Product change notification (PCN)

Title / short description	Change of appearance
Affected article category	PCB terminal blocks and PCB connectors
Change category	Form and appearance
Change number	CAA260102-00
Reason for PCN/PDN Revision

h: Height of skid

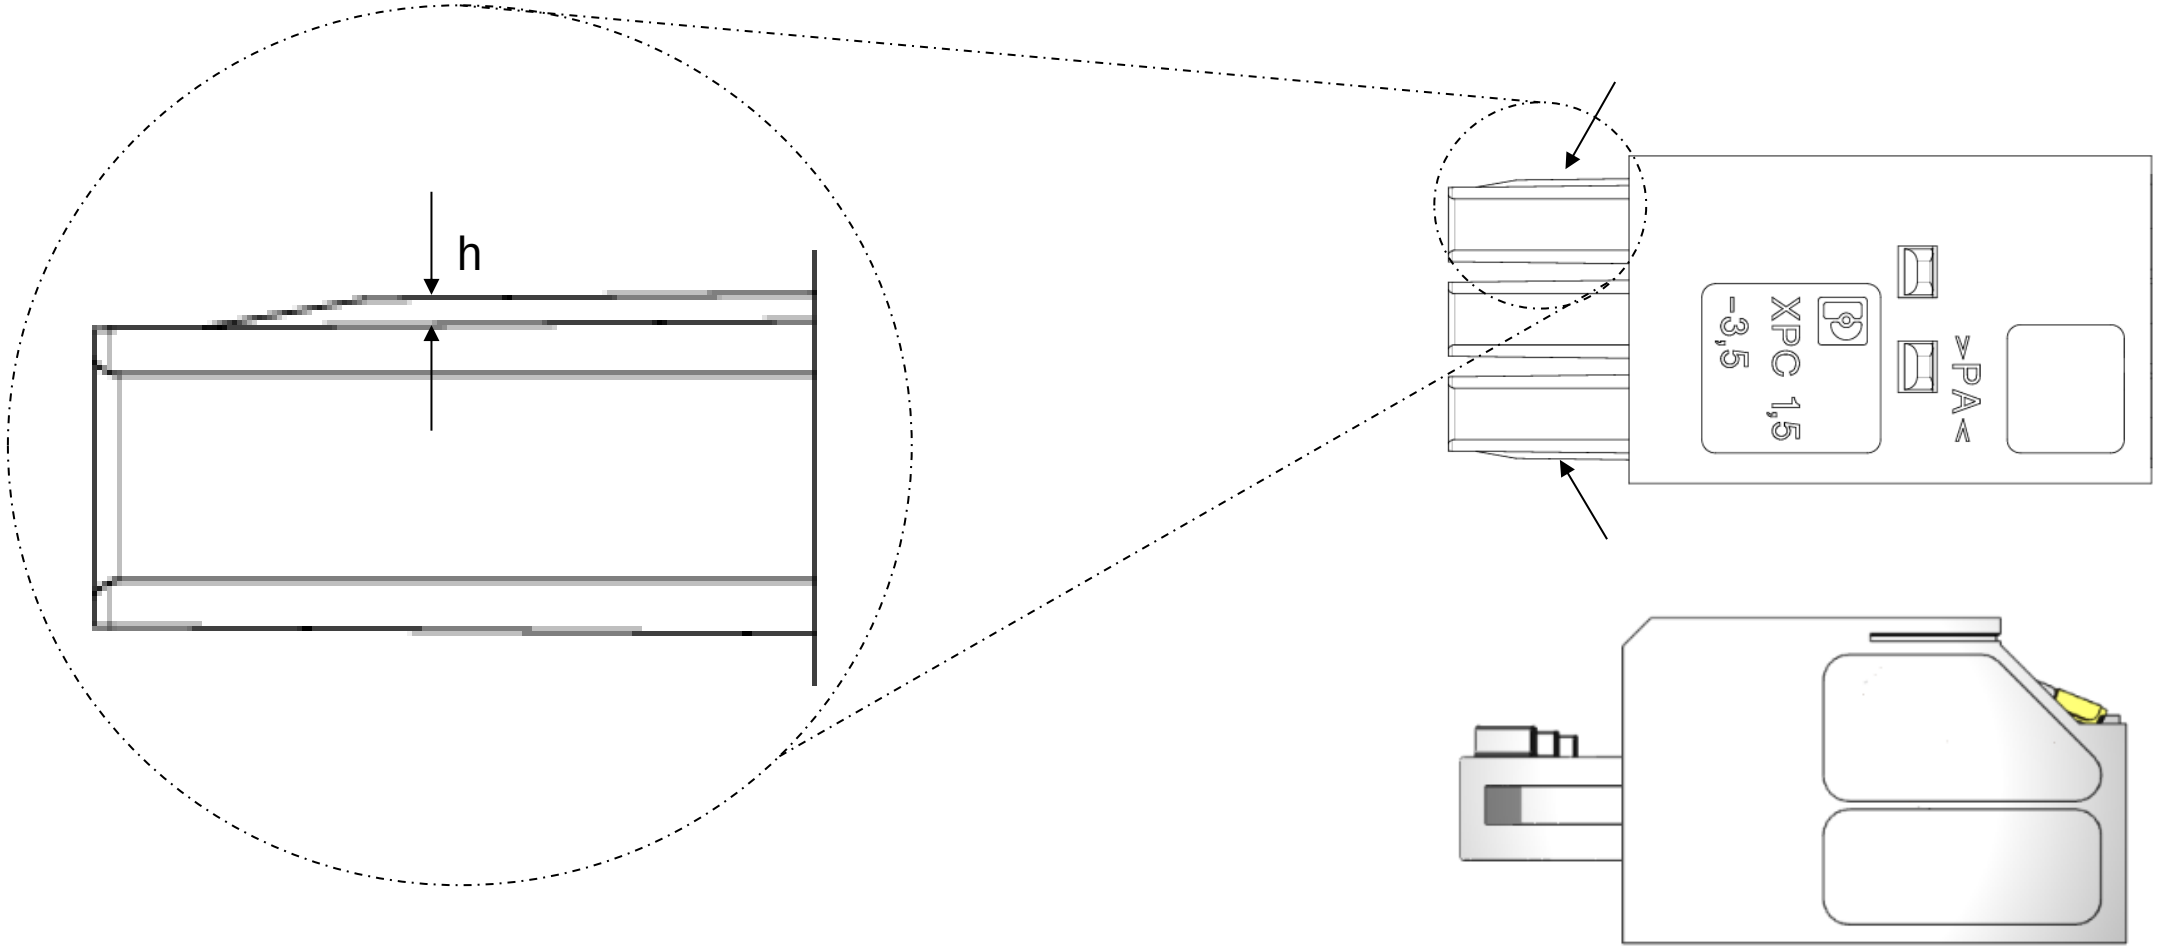
The skids located on the mating face of the connector plug have been aligned with the overall product portfolio. The skid height at both outer poles of the connector plug has been reduced. The attached drawing illustrates the position of the skids on the connector plug.
